INTERNATIONAL STANDARD

AMENDMENT 1

**Digital audio – Interface for non-linear PCM encoded audio bitstreams applying IEC 60958 –
Part 5: Non-linear PCM bitstreams according to the DTS (Digital Theater Systems) format(s)**

Figure 7 – DTS type IV single burst mode

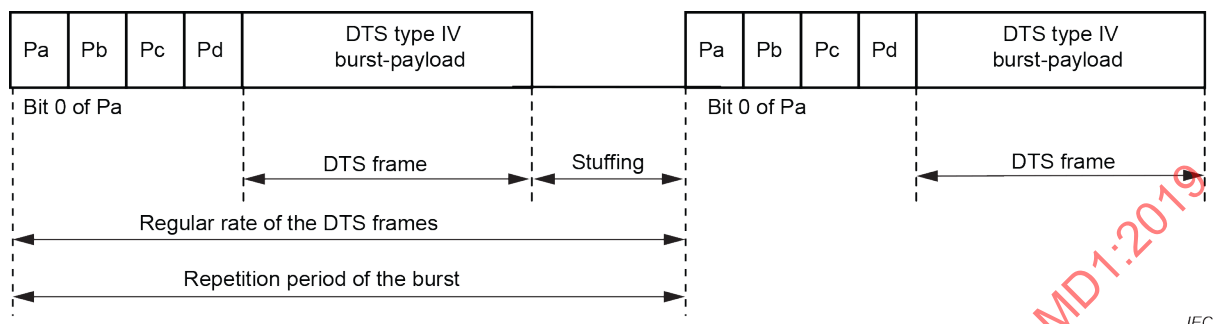
DTS type IV profile 0 shall deliver a DTS audio frame in a each burst. The burst repetition period, indicated with bits 8 – 10 of Pc, is relative to the period of the IEC 60958 frame. Figure 7 provides a representation of the repetition period of the burst.

Move Figure 7 from 5.3.4 to this position in 5.3.5.1, and replace the existing Figure 7 with the following new Figure 7:

Figure 8 – Decoder latency of DTS type IV single burst mode

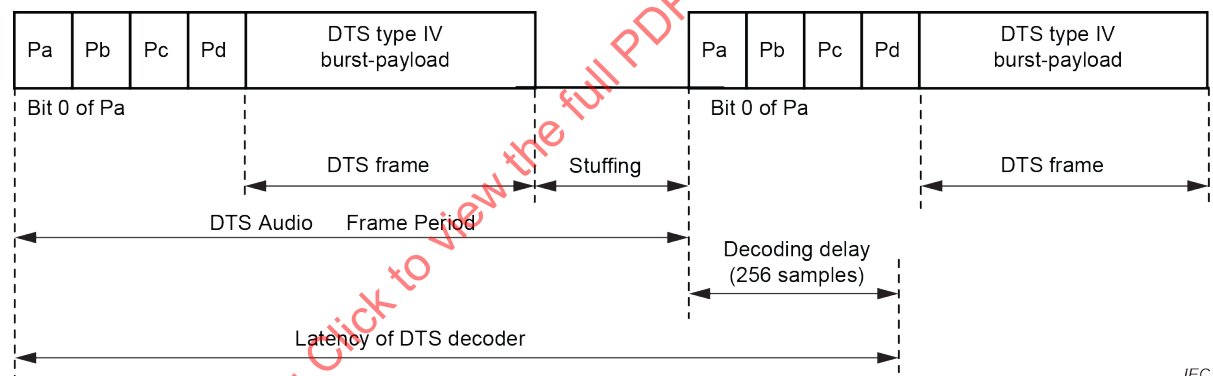
The decoder latency of a DTS stream delivered using DTS type IV single burst mode is shown in Figure 8.

Move Figure 8 from 5.3.4 to this position in 5.3.5.1, and replace the existing Figure 8 with the following new Figure 8:

NOTE 2 The latency of a DTS decoder is defined as a delay measured from the reference point, and equal to one frame (10,67 ms) plus one subframe (256 samples at 48 kHz, or 5,33 ms), equivalent to 16 ms.

Figure 9 – DTS type IV multi-burst mode

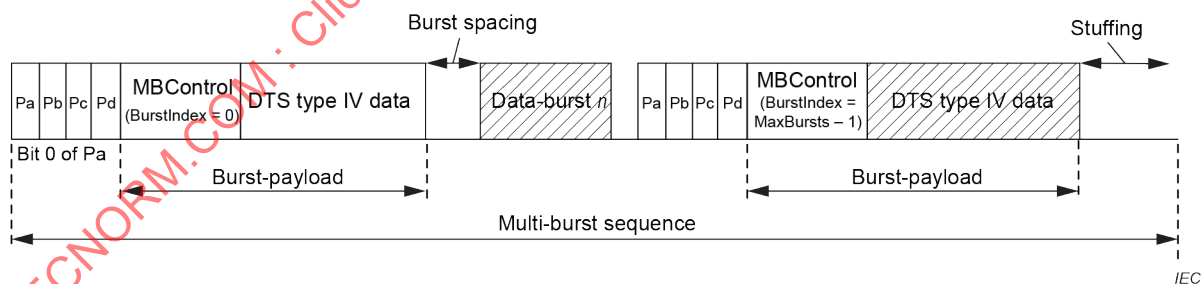
A representation of a multi-burst sequence is shown in Figure 9. This representation assumes the case of 2 or more data-bursts per multi-burst sequence, and any data-bursts between the first and last data-burst are represented as data-burst n .

Add the following new Figure 9:

Figure 10 – Decoder latency for DTS type IV multi-burst mode

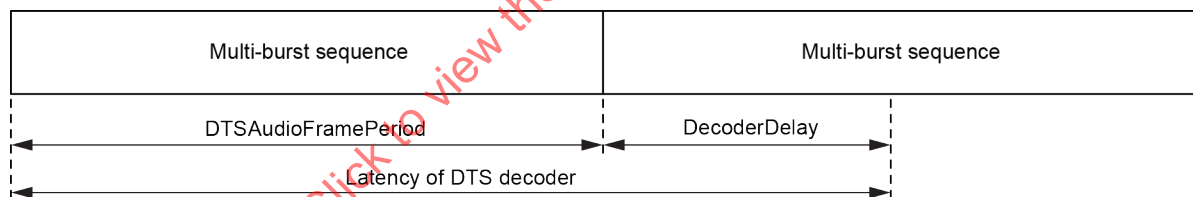
Decoder latency for audio delivered using multi-burst mode is illustrated in Figure 10.

Add the following new Figure 10:
